**Flood Control Project Maintenance  
Levee Inspections**

## Maintenance Issue Types Only, Levee Inspection Report By Mile - Spring 2018

### Sacramento Maintenance Yard Putah Creek

Waterway	Bank	Unit Miles	Inspection Start/End	Inspector
Unit No. 01 Putah Creek or North Levee	Left	8.79	03/08/2018 03/08/2018	Keith Millard

Photo 1 of 1 : SP\_2018\_ST0007\_283\_47\_20180305\_00013.jpg

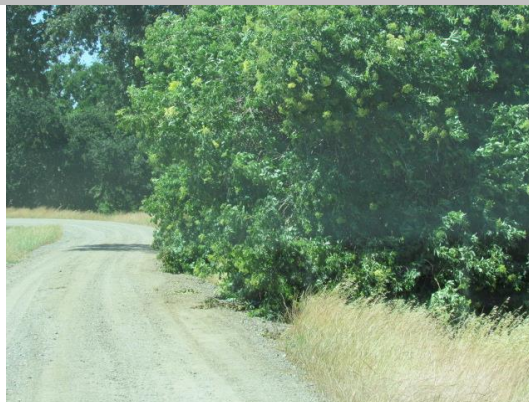
LM Start	7.00	Rating **	U	Issue No.	47
LM End	7.01	Issue Type +	Ma	Location *	WS
Category	Earthen Levee			GPS Latitude/Longitude	
				Start	End
Item	Vegetation			38.522328 °	38.522393 °
				-121.781447 °	-121.781663 °
DWR ID	DWR_ST0007_02_s_2017_47				
Comment Code					
V4 : Elderberries are blocking visibility and flood fight capability.					
Inspector Comment					
These Elderberries are blocking view of levee section and blocking access to a portion of the shoulder waterward. Some of these stalks are less than 1.0 inch that could be thinned out.

Elderberry bushes blocking view of waterside shoulder at this location.
